Integrated Transport Assessment Tamahere Village Hub

Waikato District Council

ISSUE 1, 23 FEBRUARY 2017

Foster Developments Ltd have applied for land use consent for a development in Tamahere. Waikato DC asked Gray Matter to review the traffic assessment in the application and extend it to consider how best to treat the Birchwood Lane/Devine Road intersection.

Figure 3: Waikato District Plan – 23B.4 Tamahere Village Concept Plan

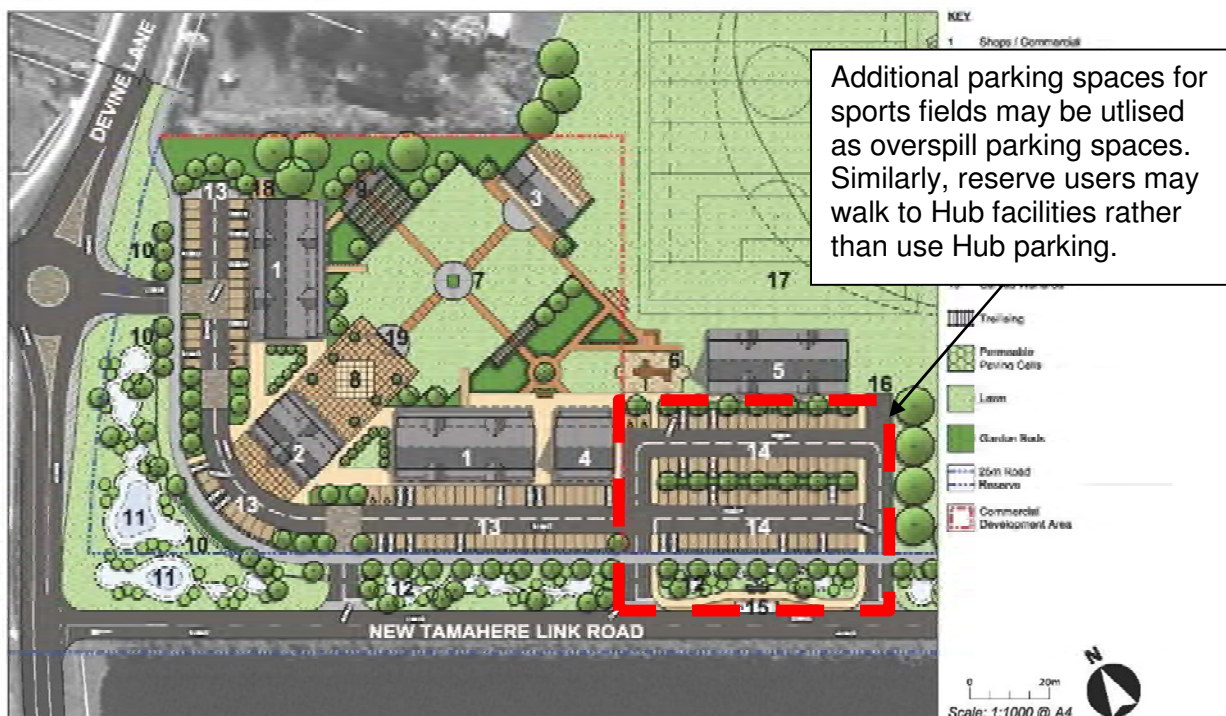
The vehicle crossing on Devine Road forms a crossroads intersection with Birchwood Lane and Devine Road. There is approximately 90m separation from the Devine Road/Wiremu Tamihana Drive intersection. The Tamahere Village Concept plans show a roundabout with a fourth leg for access into the Village. The proposed access arrangement does not currently show a roundabout.

Our preferred option is a roundabout at the Birchwood Lane/Devine Road intersection (Layout 2). The option is consistent with the concept plans and provides the safest form of intersection. Layout 3 would be desirable but the cost of construction is likely to be greater than Layout 2.
